June 12, 2014
ADDENDUM NO. 1
WOODS CHAPEL ROAD IMPROVEMENTS
NW CASTLE DRIVE TO WALNUT STREET
903 W. Main Street
Blue Springs, Missouri
Project No. 08-08-02

Addendum Item No. 1

The intent of this addendum is to define changes to the Contract Documents as advertised May 15, 2014 as noted below.

SHEET NO.
17

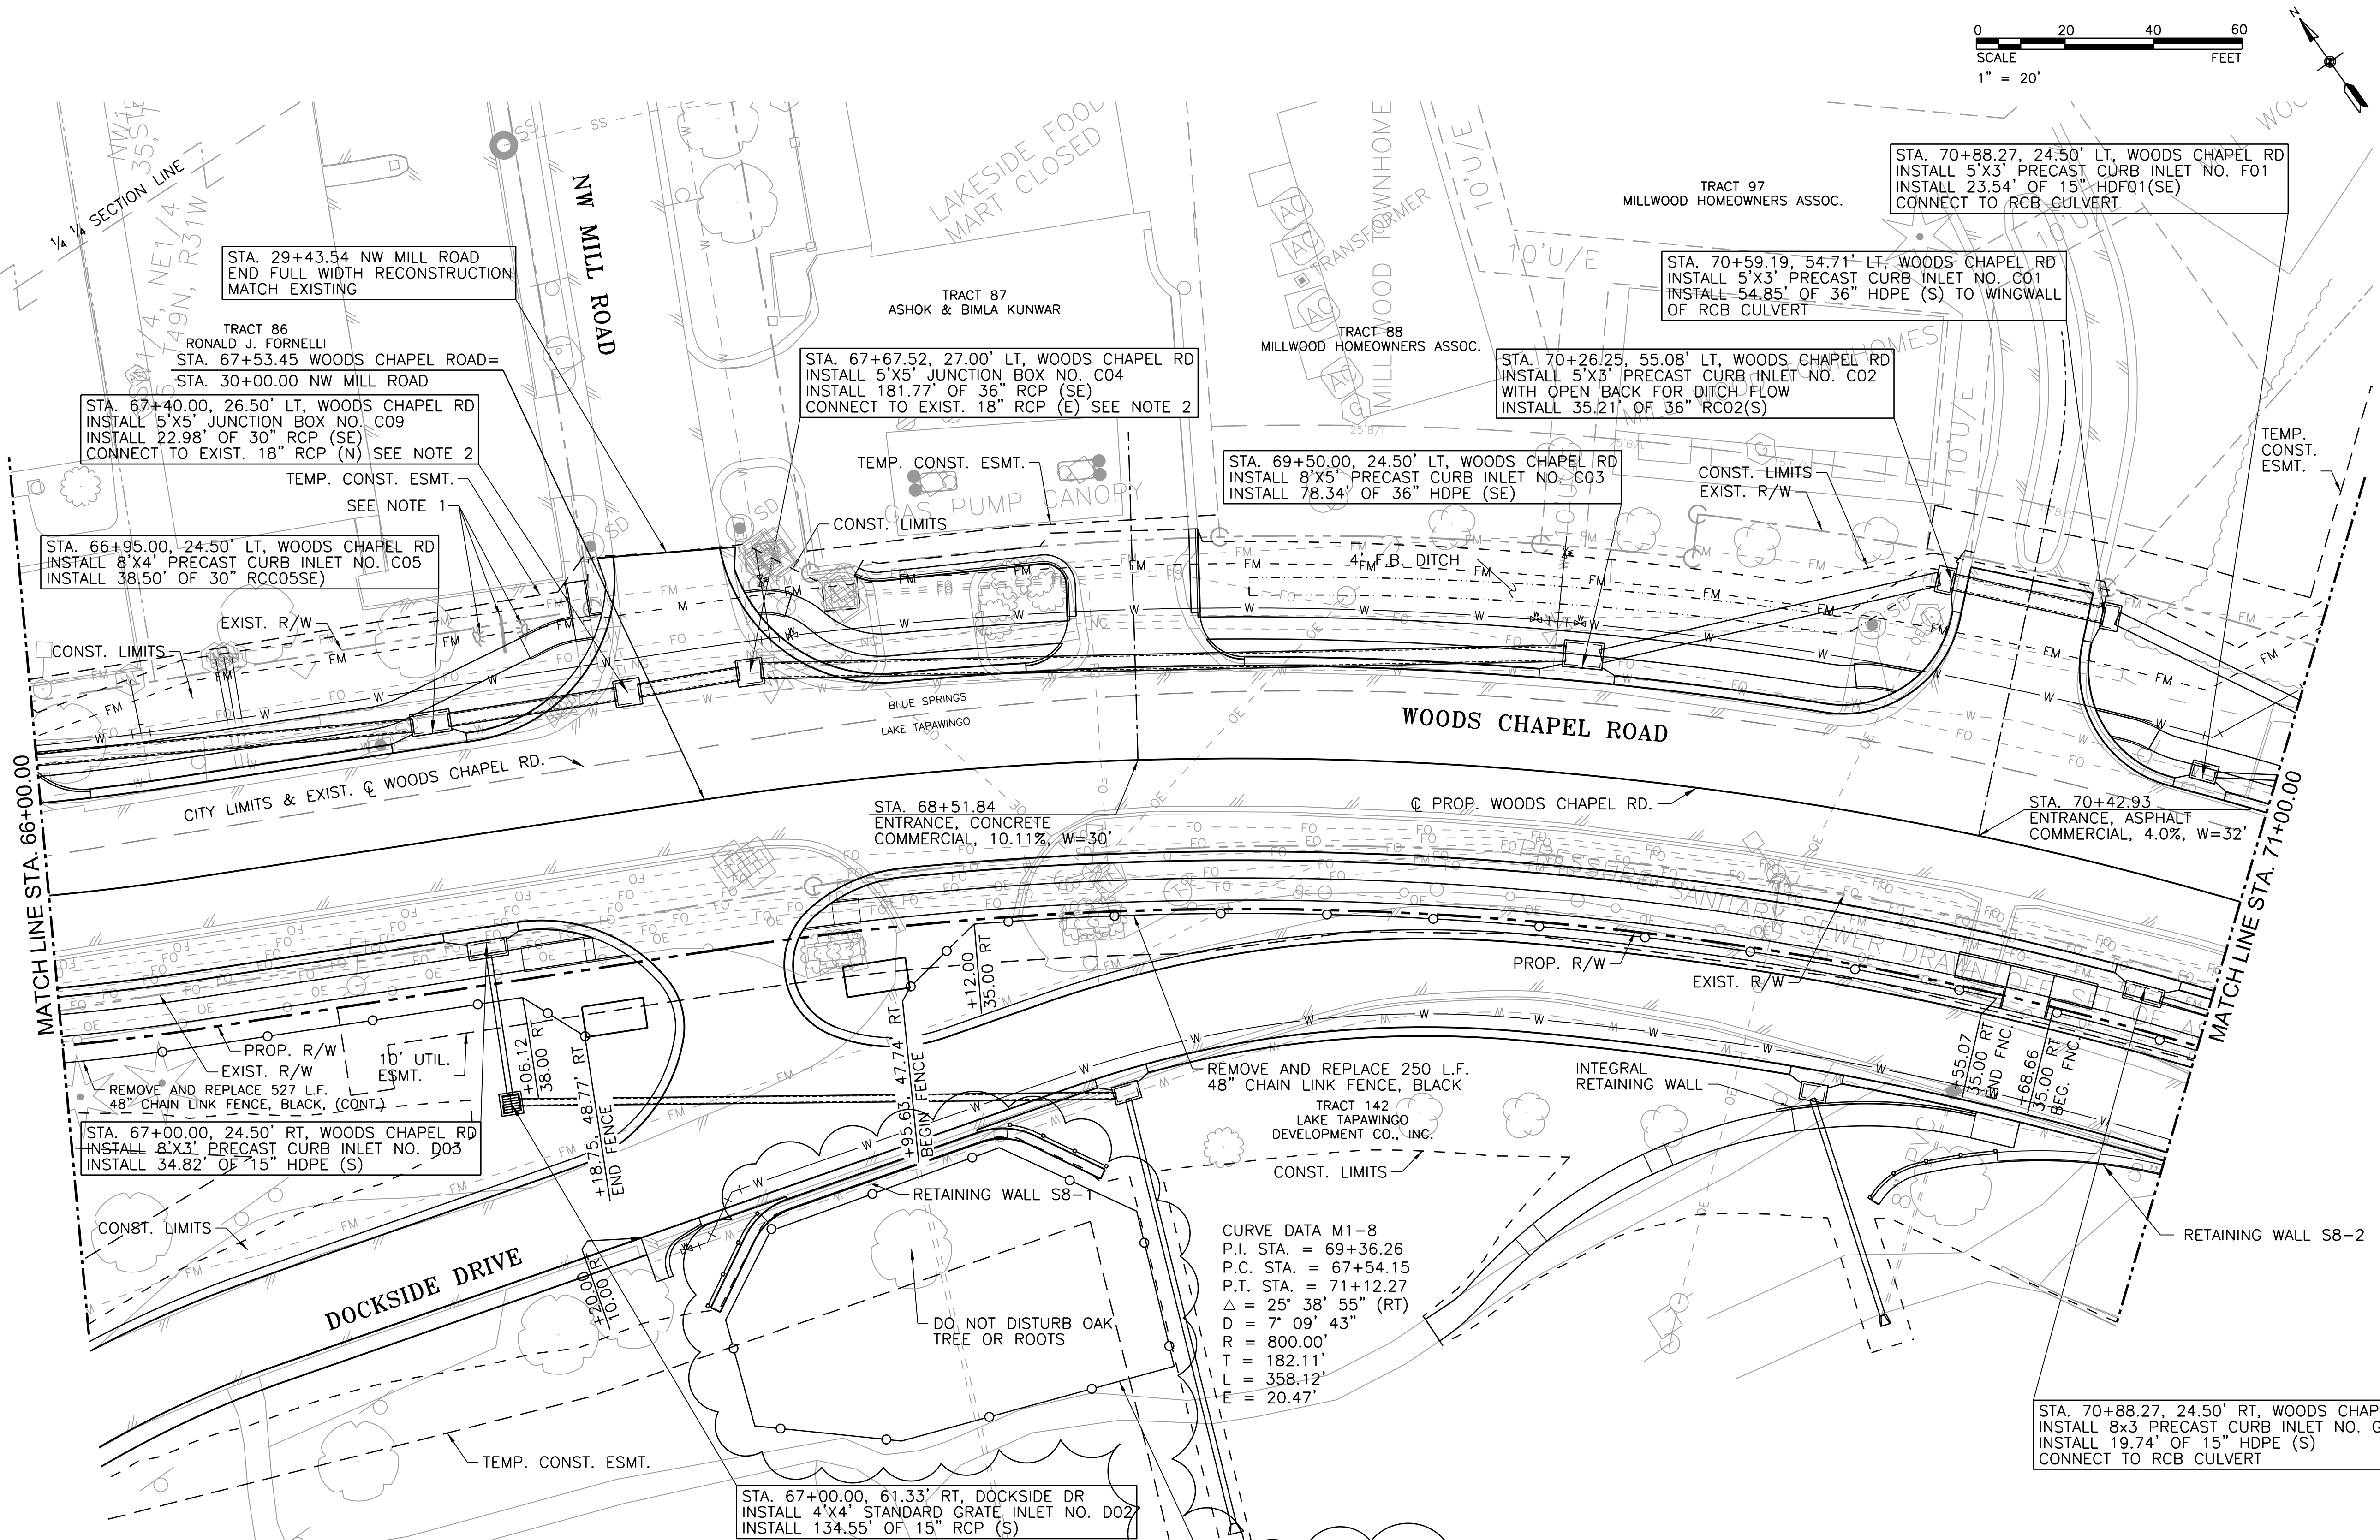
- All items beyond # 24 have been renumbered to accommodate the addition of the 12" Eccentric Plug Valve.
- **Plan Sheet 17 revised to show approximate location of tree protection fencing.**

Question – Would you consider adding a bid item for the tree protection fence?

Answer – An approximate location of the tree protection fence has been added to sheet 17 (revised sheet is part of this addendum). No bid item will be added. The fence is only to be used for one tree near Dockside Drive and Mill Street and will be subsidiary to other items.
